Well Name: POKER LAKE UNIT 15 TWR	Well Location: T24S / R31E / SEC 22 / NWNW / 32.208749 / -103.772453	County or Parish/State: EDDY / NM
Well Number: 116H	Type of Well: OIL WELL	Allottee or Tribe Name:
Lease Number: NMNM0506A	Unit or CA Name: POKER LAKE UNIT	Unit or CA Number: NMNM71016X
US Well Number: 3001554170	Operator: XTO PERMIAN OPERATING LLC

Type of Action: APD Change

Poker Lake Unit 15 TWR 116H

SUNDRY LANGUAGE

ACREAGE DEDICATION PLATS

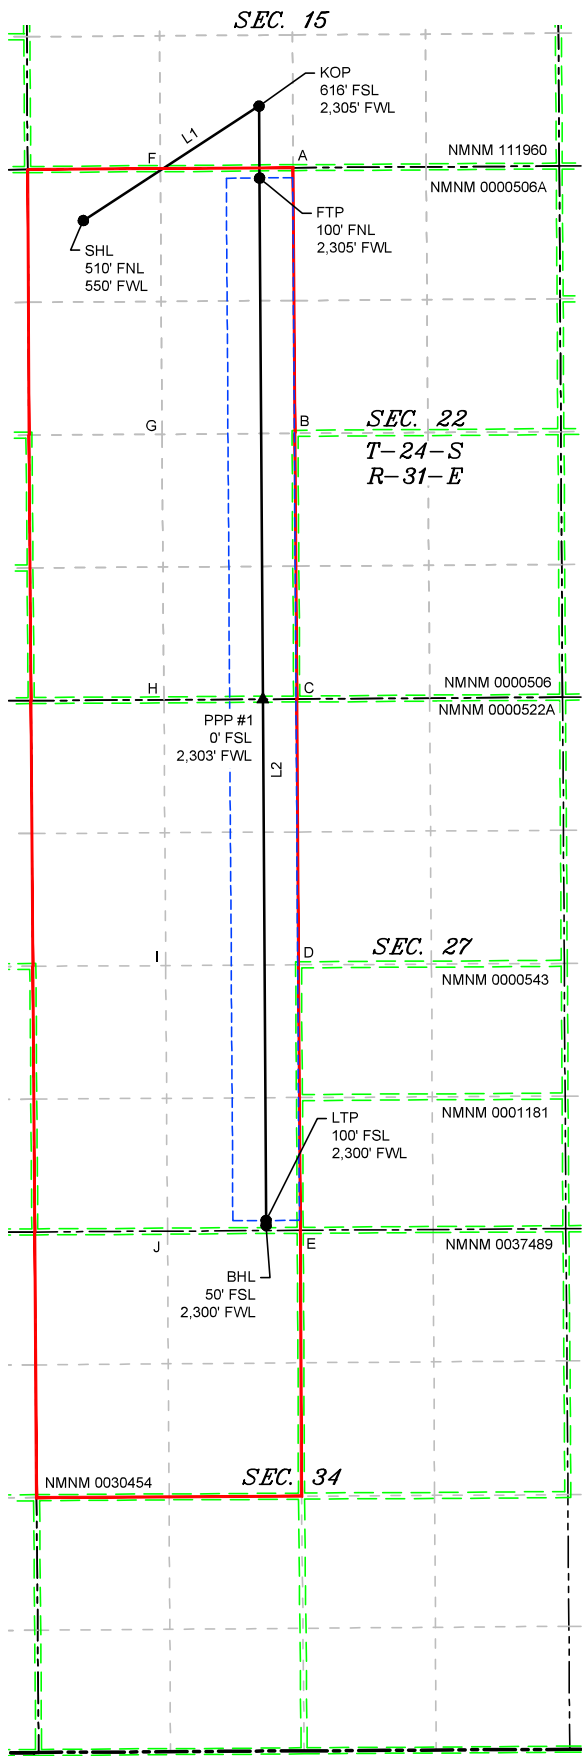
XTO Permian Operating, LLC. respectfully requests approval to make the following changes to the approved APD. Changes to include SHL, KOP, FTP, LTP, BHL, Proposed total Depth, and Pool Code. There is no new surface disturbance. There is a dedicated acreage change.

FROM: TO:
SHL: 490' FNL & 550' FWL OF SECTION 22-T24S-R31E 510' FNL & 550' FWL OF SECTION 22-T24S-R31E
KOP: 490 FNL & 550 FWL OF SECTION 22-T24S-R31E 616 FSL & 2305 FWL OF SECTION 15-T24S-R31E
Continued on page 3 additional information

FTP: 330' FNL & 1430' FWL OF SECTION 22-T24S-R31E 100' FNL & 2305' FWL OF SECTION 22-T24S-R31E

LTP: 2460' FNL & 1430' FWL OF SECTION 27-T24S-R31E 100' FSL & 2300' FWL OF SECTION 27-T24S-R31E

BHL: 2590' FNL & 1430' FWL OF SECTION 27-T24S-R31E 50' FSL & 2300' FWL OF SECTION 27-T24S-R31E
